April 3, 2014

Mr. John Bassett, P.E.
Transportation Engineer
Virginia Department of Transportation
4985 Alliance Drive
Fairfax, VA

RE: **Mayfair (formerly Autumn Hill)
Response to 1st Submission Comments – Final Development Plan (FDP)
Town of Purcellville Application RZ 13-01
BCG Project # 005184-01-008**

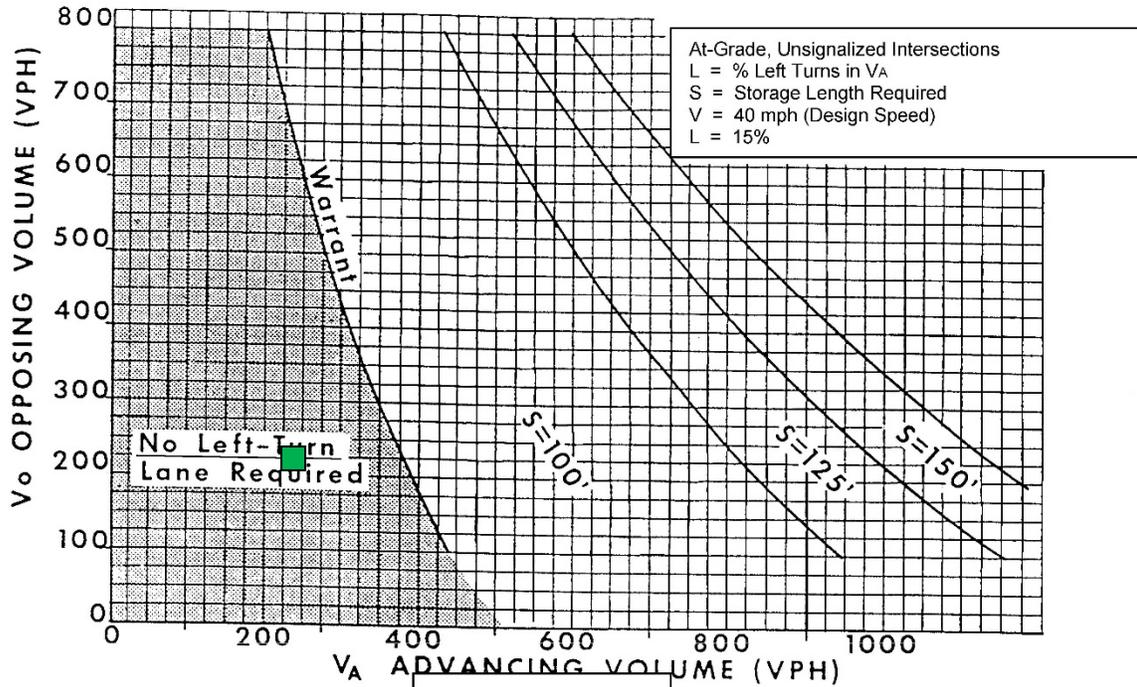
THE OPPOSING AND ADVANCING VOLUMES WERE PLOTTED ON FIGURES 3-7 AND 3-10 OF THE VDOT ROAD DESIGN MANUAL APPENDIX F.

AS INDICATED BY THE LOCATION OF THE PLOTTED POINT ON THE NOMOGRAPHS, NO LEFT TURN IS WARRANTED.
